PRODUCT CHANGE NOTIFICATION

Select Bourns® Model SRU1028 Series Shielded SMD Power Inductors

Change to Inductor Shield Design

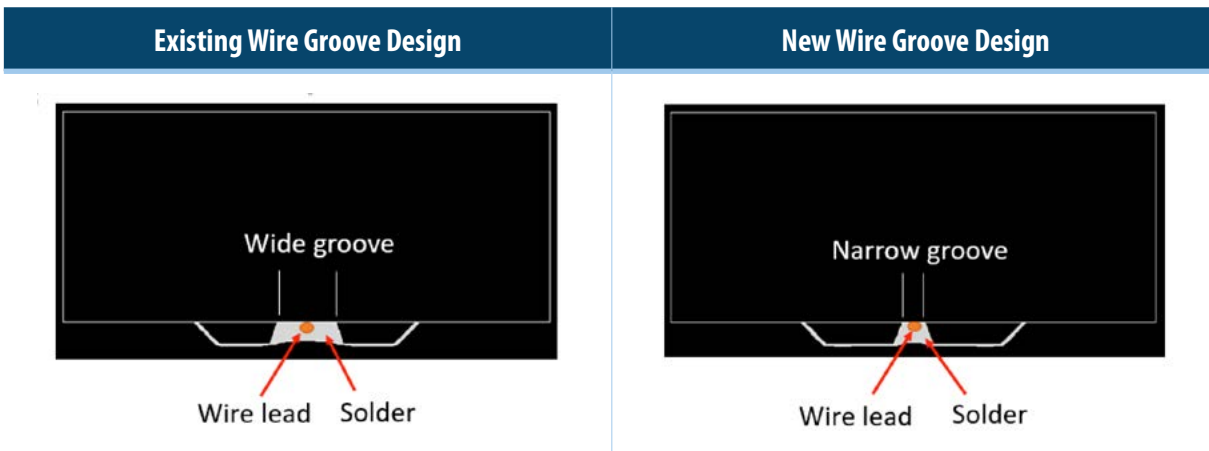
Riverside, California – July 23, 2021 – Effective January 22, 2022, Bourns will change the inductor ferrite shield design for select [Model SRU1028 Series](#) Shielded SMD Power Inductors. The wire groove of the modified ferrite shield will be narrowed which will result in a better fitting for the wire lead.

The form of the inductor will change because of the narrower wire groove. The fit and function of the inductor will remain the same. The quality and reliability of the component should be improved.
